# SCHWEIZER SERVICE BULLETIN

B-275  
12 Mar 2001

SUBJECT: ONE-TIME INSPECTION FOR CONDITION AND MODIFICATION OF CERTAIN IDLER PULLEY SUPPORT ASSEMBLIES

MODELS AFFECTED: ● Model 269C Helicopters S/N S1799, S1802, S1804 thru S1808

Figure B-275-1. Measuring Clearance between Idler Pulley and Spacer

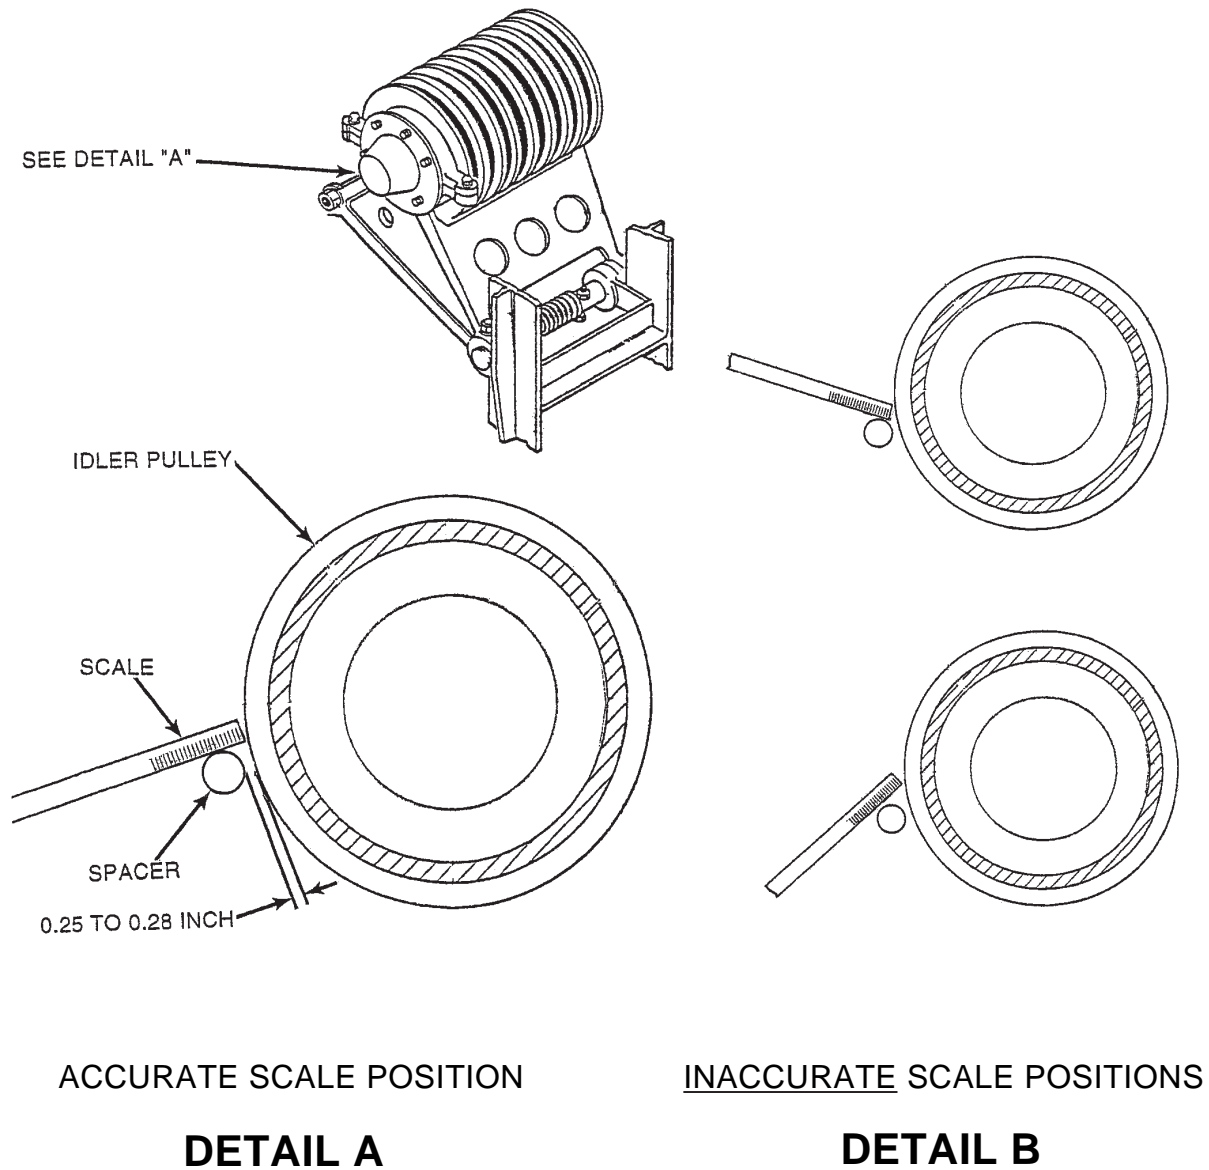
PREFACE: ● When a 269A5575-11 idler pulley support assembly is installed with 269A5437 BSC spacers (0.56 inch diameter) there is excess clearance between the spacers and the clutch drive V-belts. With this condition, the V-belt(s) could possibly jump out of the idler pulley groove(s) with the drive belt clutch disengaged. This Service Bulletin requires replacement of the BSC spacers with 0.75 inch diameter 269A5437-3 spacers which will remove the excess clearance between spacers and V-belts.

In next step, when measuring clearance between outer edge (rim) of idler pulley and spacer, insure that position of scale and angle of sight are correct to measure the distance between the closest points of the two components (Figure B-275-1, Detail A). Unacceptable assemblies measure approximately 0.35 inch between pulley and spacer; **AND** belts can be manually deflected out of pulley grooves.

- (2) Measure distance between outer edge of idler pulley and spacer; it should be approximately 0.25 to 0.28 inch. If this measurement is correct, it verifies that a 269A5575 BSC, -3, -5, -7, or -9 assembly is installed; **OR** that a 269A5575-11 assembly is installed with larger diameter (0.750 inch) 269A5437-11 spacers. In either event, no further action is required; record compliance (step e. below). If measurement is greater than 0.25 to 0.28 inch, proceed to step c.

- c. Remove the 269A5437 BSC spacers and replace with 269A5437-3 spacers using applicable steps of Basic HMI, Section 10. Check measurement specified in step b.(2) above.
- d. Install V-belt drive cover shell and hat (Basic HMI, Section 10).
- e. Record compliance with this Service Bulletin in the aircraft records.
